Pro-Torq® Axle Nut Retaining Keeper 450-4973 Design Change

TO: DISTRIBUTORS OF STEMCO WHEEL END PRODUCTS

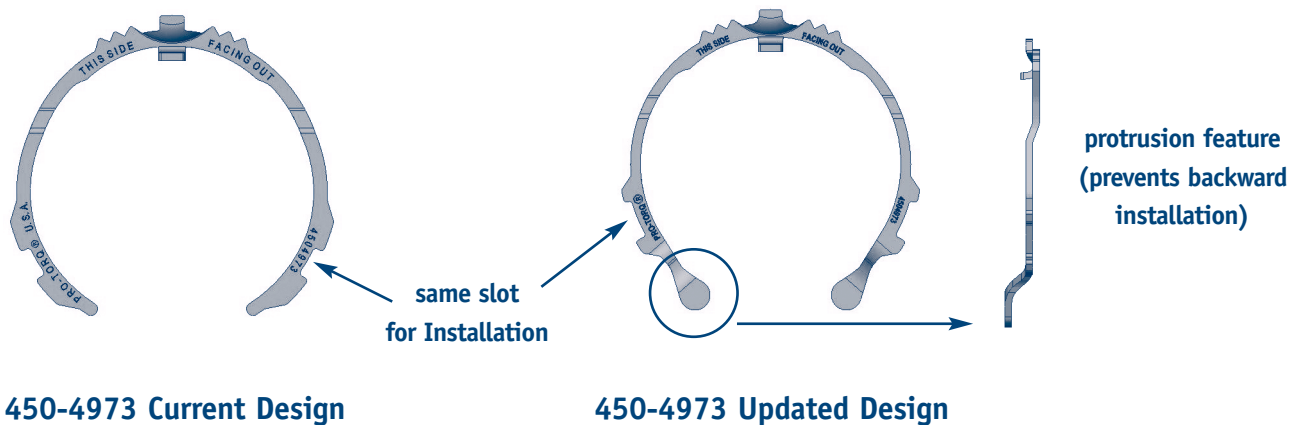
STEMCO, supplier of the Pro-Torq® axle nut, is releasing an updated design for the 450-4973 retaining keeper, as shown below. The design is a running change that adds an enhancement that prevents improper (backward) installation of the keeper. Upon depletion of current inventory STEMCO will begin shipping the new design keeper, on or around November 15, 2006.

This change is the result of customer input for design improvement to help install the keeper correctly every time. In addition to the orange paint and stamping "THIS SIDE FACING OUT", the new feature is a physical alteration to help avoid installing the keeper backward.

Please note the geometry differences between the current and new keeper designs as pictured below. There will be no changes in installation procedures or keeper performance, but users will notice the modification to the geometry of the 450-4973 keeper.
